**RE: Mister Car Wash
1020 Juan Tabo Blvd NE
Grading and Drainage Plan
Engineer's Stamp Date: 10/22/25
Hydrology File: J22D074
Case # HYDR-2025-00392**

Based upon the information provided in your submittal received 10/30/2025, the Grading & Drainage Plans are not approved for Building Permit. The following comments need to be addressed for approval of the above referenced project:

ENGINEER'S SEAL	MISTER CAR WASH ALBUQUERQUE, NM	DRAWN BY pm
		GRADING AND DRAINAGE PLAN	DATE 10-22-25
			DRAWING
			SHEET # 5
			JOB # 2025017

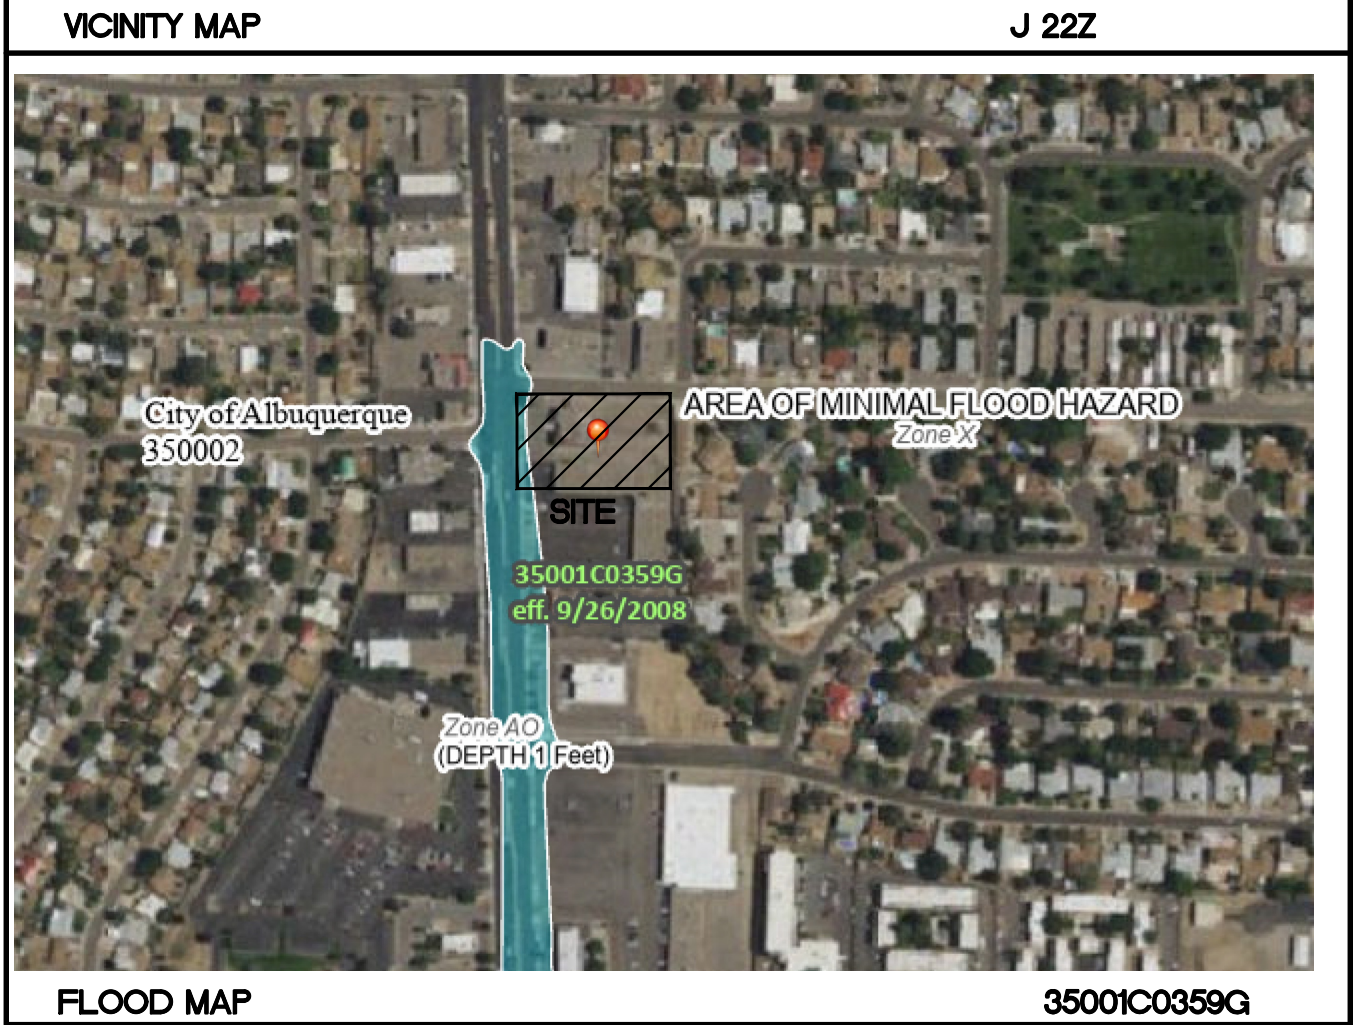
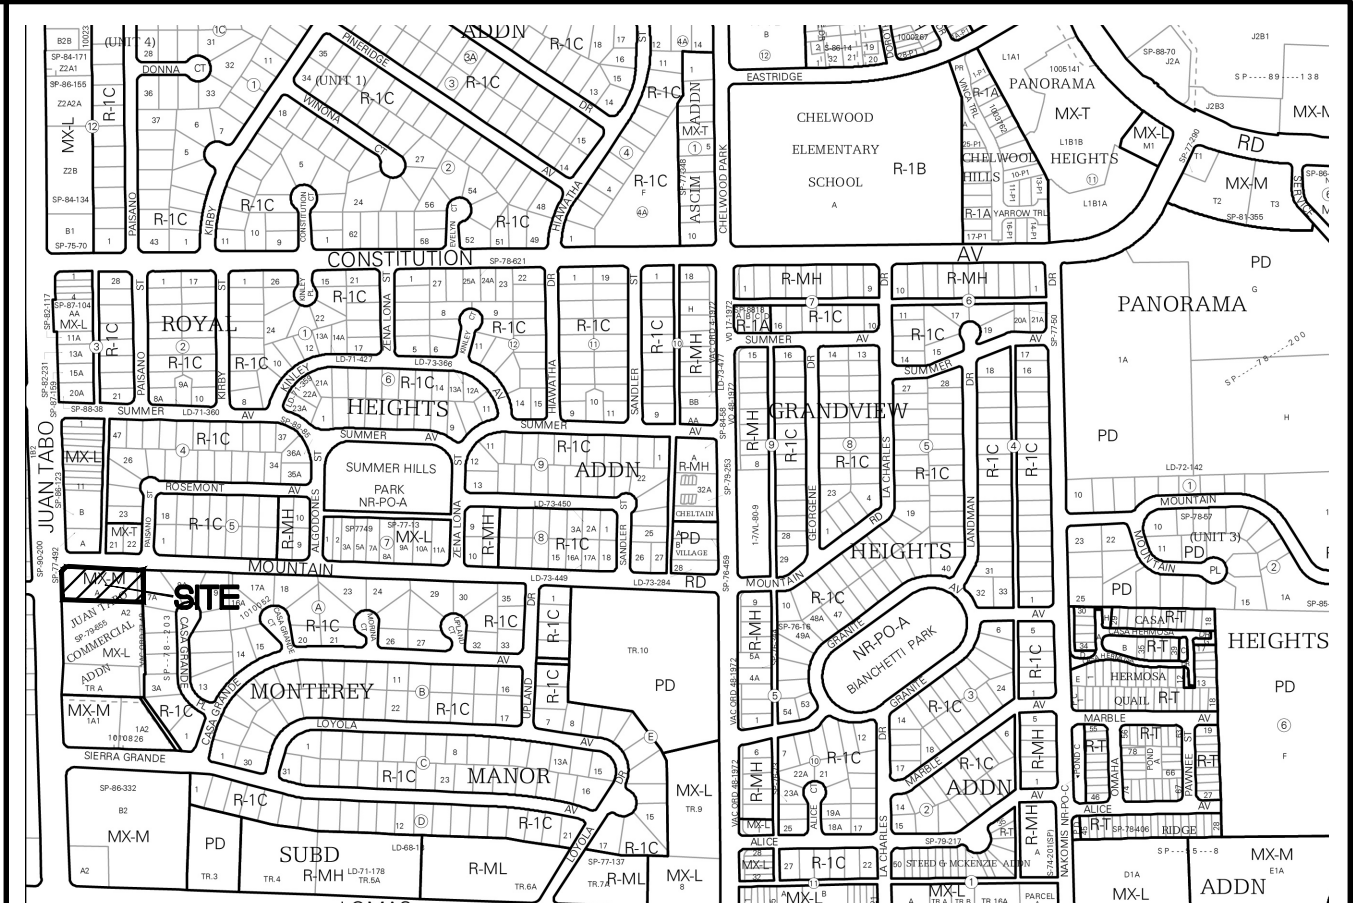
1. A portion of this project is located in a floodplain (AO-1') and a floodplain development permit must be obtained. The permit application must demonstrate zero rise to the base flood elevation, unless a Letter of Map Revision (LOMR) is being prepared. Please contact Rudy Rael, CFM for more information regarding floodplain development permits (rrael@cabq.gov or 505-924-3977).

2. Please show the SFHA boundary on the plan.
3. Please update the floodplain note with the SFHA information.
4. Please state the 100-year BFE and verify that the proposed FF elevation is sufficient.
